American Council of Engineering Companies of New York

Comments
Residential Tower Mechanical Voids Amendment 2
Central Business Districts – April 2020

Submitted to NYC Department of City Planning- June 3, 2020

Figure 3. Measurement from the top of a structural floor to the bottom of a structural floor slab

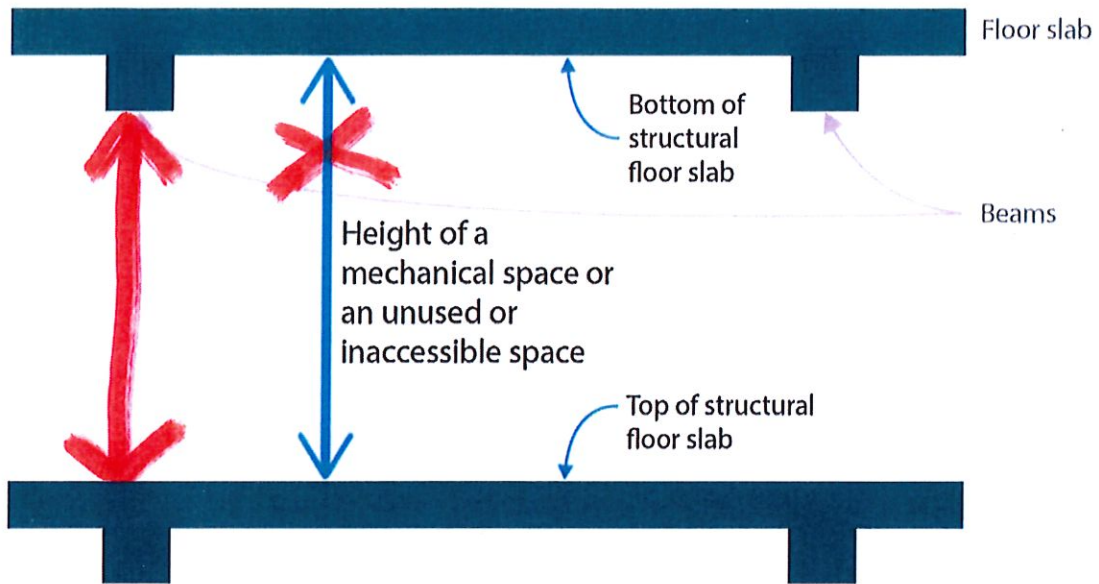
- To determine the height of each floor, measurement should be taken from the top of the structural floor slab up to the underside of the deepest structural element – *not* to the bottom of the floor directly above. In some cases, structural elements (i.e. beams, joists, etc.) extending down into mechanical floors are required to be quite large and the space in between these elements cannot be efficiently utilized by the mechanical systems, thus reducing the usable height of the mechanical floor. We have attached a previously submitted annotated sketch depicting the intent of this comment.

Item 5 ZR 23-16(a)(2), interpretation of “...the height of such floor space shall be measured from the top of a structural floor to the bottom of a structural floor directly above such space.”

To determine the height of each floor, measurement should be taken from the top of the structural floor to the bottom of the structural floor slab next above. Measurements of floor height are not to be taken from the finished floor to the bottom of a drop ceiling above. In the case of a structural coffered ceiling (e.g. waffle slab or space frames), measurement shall be taken from the top of the structural floor to the bottom of the structural floor slab. Figure 3 indicates how floor height should be measured.
